From: [Brian Bates](#)
To: [Sandy Vossler](#)
Subject: Re: Lanterns SDP
Date: Wednesday, February 13, 2019 10:43:28 AM

My comment regarding the SDP for the Planning Commission meeting follows:

From: [Sandy Vossler](#)
To: ["Gerald Morrison"](#)
Cc: [Scott Carlson \(ScottCarlson@carlsonland.net\)](#)
Subject: RE: Lanterns SDP
Date: Friday, February 22, 2019 2:23:00 PM
Attachments: [SDP - Grading Sheet.pdf](#)
[image008.png](#)

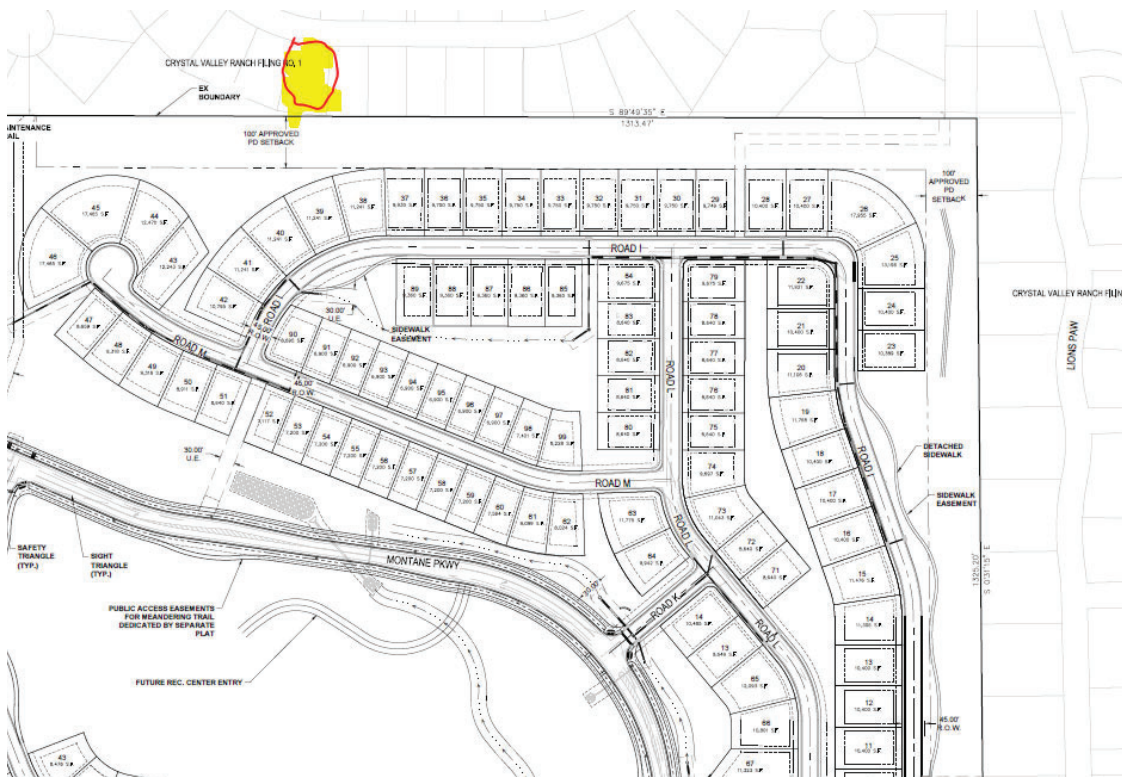
Our home is where I've highlighted in yellow and red below. The 100' setback will benefit those of us on the south side of Antelope Ridge. The older lot layout plans on the CR website show fewer homes in that corresponding neighborhood and an 80' buffer. Looks like the current density of that area is much greater now with additional roads. Since the citizens lost their fight to keep the number of homes from the original plan of 548 (now doubled to over 1200 units), my main concern is the increased amount of traffic that will be using Crystal Valley Parkway and the frontage road. Until the freeway interchange is completed, there will be a huge traffic problem on these roads. Additionally, as the World Academy charter school continues to expand, that will severely impact traffic during the morning and afternoon drop off and pick up times. I've already seen traffic backed from Wilcox and Plum Creek clear back to the car dealerships during the afternoon.

Yes, do, please call me. I'm not certain where your home is. The 100' buffer and the 250' transition zone has been accounted for as required by the zoning. I have requested changes regarding the rear lot line configurations in the portion of Phase 1 located between the Montane Parkway and north of Road B, shown in red below (this is PA 1 on the PD Plan), because the required undulation was not provided. The next submittal will include a revised lotting plan for that area that abides by the general boundaries of PA 1 on the zoning document. Beyond this, I am interested to hear your concerns and what you believe has changed. Thank you, I look forward to hearing from you. Sandy

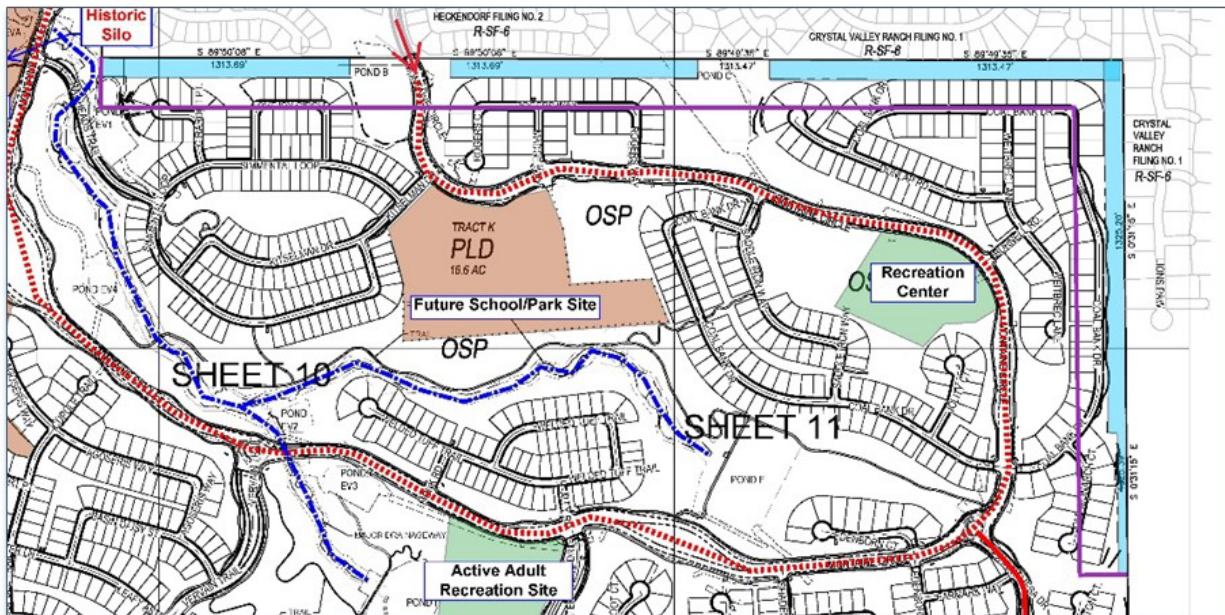
During the last Major Amendment process an agreement was reached to establish a 100' setback on the East and North boundaries of the development. In reviewing the SDP, it appears, that there is a sidewalk planned which encroaches upon this setback at the East boundary. I believe that this encroachment should be rectified before the SDP is approved.

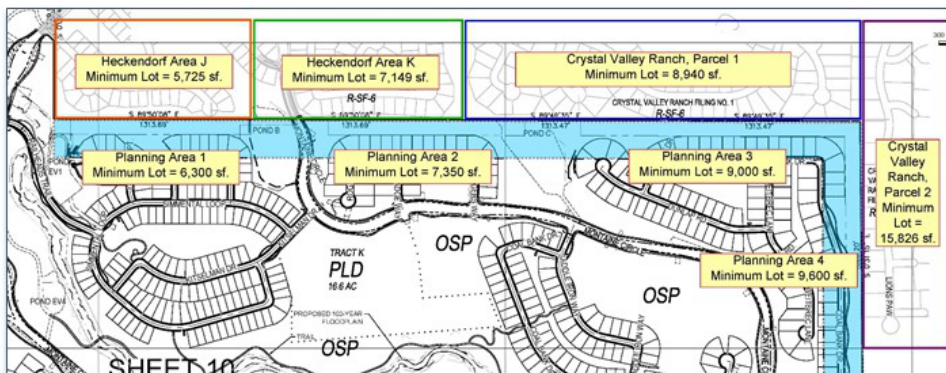
I wanted to follow up, however and answer some of the questions that you asked about the buffer and the grade. As you noted the information you received from the realtor and neighbors about a 250-foot buffer was not correct, but I also wanted to clarify that it isn't something that changed during the planning of the Lanterns. In 2006 a site plan was approved for the Lanterns that provided a 10' to 60' buffer along the north and east property boundaries. With the 2014 zoning of the Lanterns two conditions were created along the north property boundary with Heckendorf Ranch, and the east property boundary with Crystal Valley Ranch (and specifically the properties along Lions Paw). The first is a required 100-foot setback buffer; an increase over the previously approved buffer. This buffer is measured from the property boundary line to the rear lot lines of the properties within the Lanterns. Residential structures are not permitted to be built within this 100-foot buffer. That buffer area is shown in light blue below. The second condition of the 2014 zoning is the 250-foot transition zone, shown with the purple line below. I believe this is where the confusion lies.

The 250-foot Transition Zone outlined in purple above, and shaded in blue below is not a setback or a buffer. It is an area intended to provide a transition between the Lanterns and the adjacent existing neighborhood. Lots that are within the Transition Zone have specific lots widths and sizes that were established in the Lanterns zoning, which have been applied to the site plan. In most instances, the lot widths and area meet or exceed the size of the lots in the adjacent filing. The illustration below provides a comparison of the lot sizes in the Lanterns compared to the surrounding development.

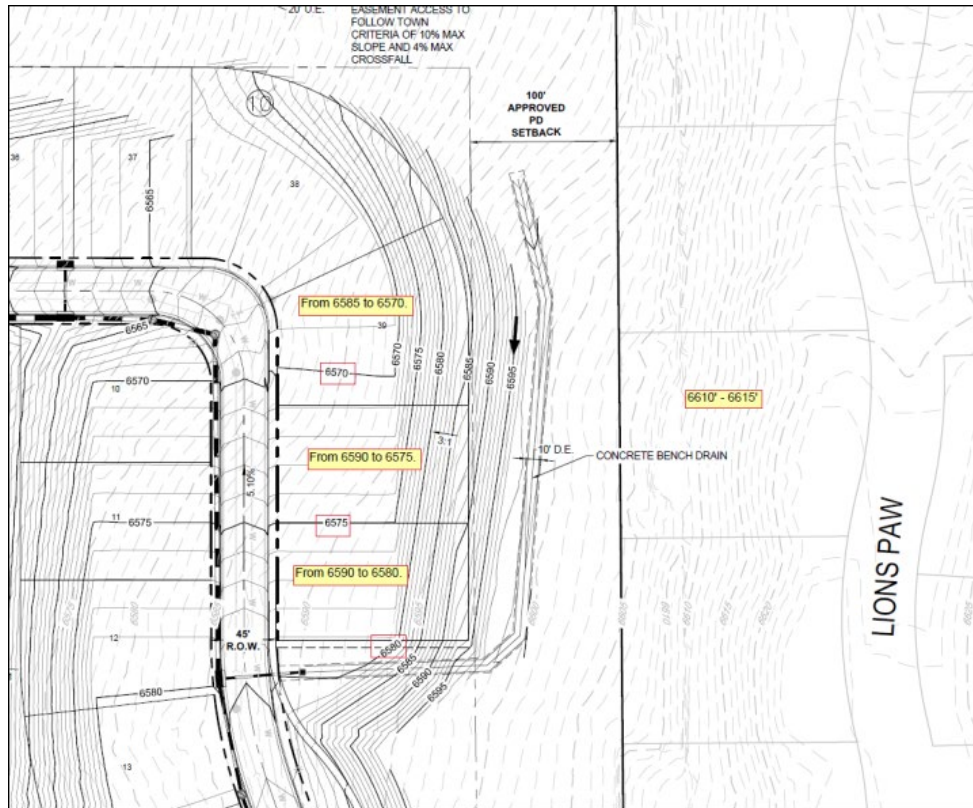
Finally, I've looked back over the proposed grades at this corner of the Lanterns development. See the attached grading plan and snapshot below. In addition to the 100-foot setback buffer, the rear lot lines of the Lanterns properties are approximately 20 feet lower than your rear lot line. The elevation at the mid-point of your lot is approximately 6,610-6,615 feet, roughly where your foundation would be. The grade of the building pad for the three lots to the west of your lot, ranges from 6,570' on lot 39, to 6,580' on lot 41. All three lots are being lowered an average of 15' from the natural grade and will ultimately be approximately 35' lower than finished grade of your foundation. It does appear that there is significant grading proposed for this plateau area, as Mr. Carlson had indicated may be a possibility. I hope that this information is helpful and has answered some of your questions. Please let me know if you have any other questions or need additional information. Regards, Sandy
